CITY OF ALBUQUERQUE

**RE: Risen Savior Catholic Community Parking Lot
Grading and Drainage Plan
Engineers Stamp Date 5/5/16 (D19D002)**

RISEN SAVIOR CATHOLIC COMMUNITY
PARKING LOT IMPROVEMENTS
7810 SCOTTS PL. NE
ALBUQUERQUE, NEW MEXICO 87120

SHEET TITLE
GRADING & DRAINAGE PLAN

DRAWING SHEET
CG-101

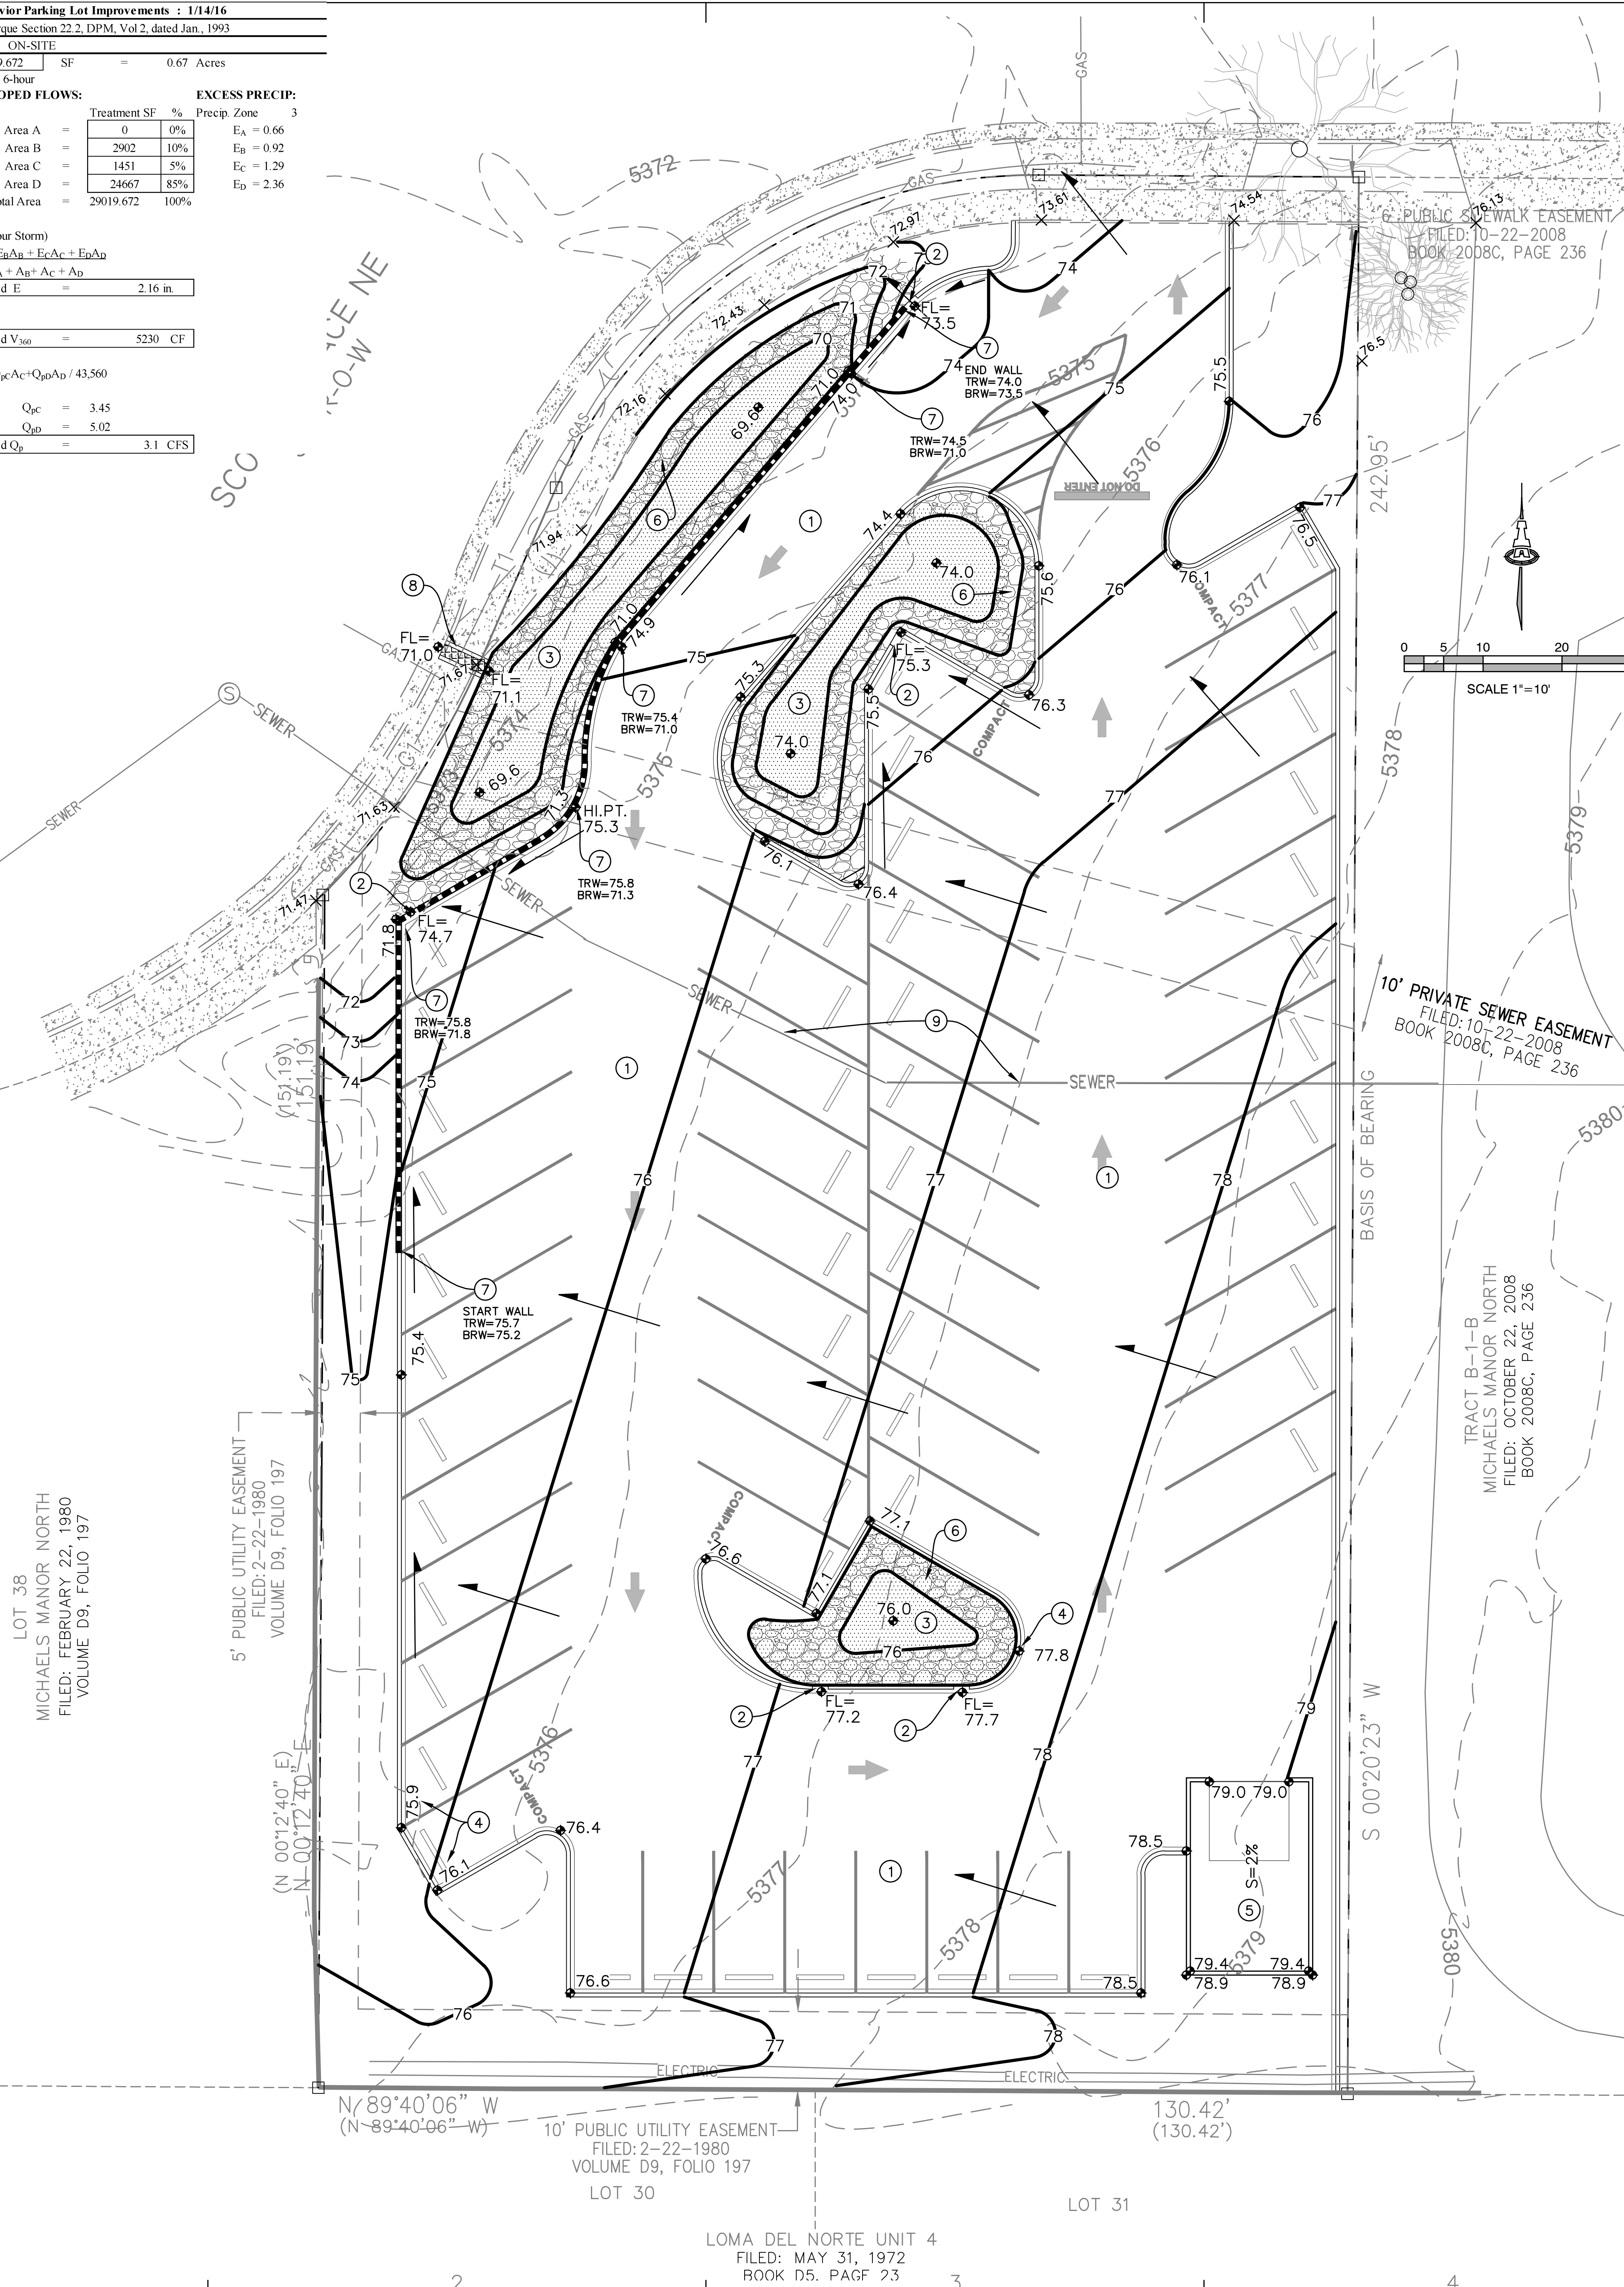
Based upon the information provided in your submittal received 4/27/16, this plan is approved for Grading Permit, Paving Permit and SO-19. Contact Jason Rodriguez at 235-8016 to schedule an inspection for the side walk culvert. A separate Excavation/Barricading Permit is required for SO-19 construction within City ROW. A copy of this approval letter must be on hand when applying for the permit.

Prior to release of approval for the parking lot, an approval letter from Jason Rodriguez for the sidewalk culvert will be required.
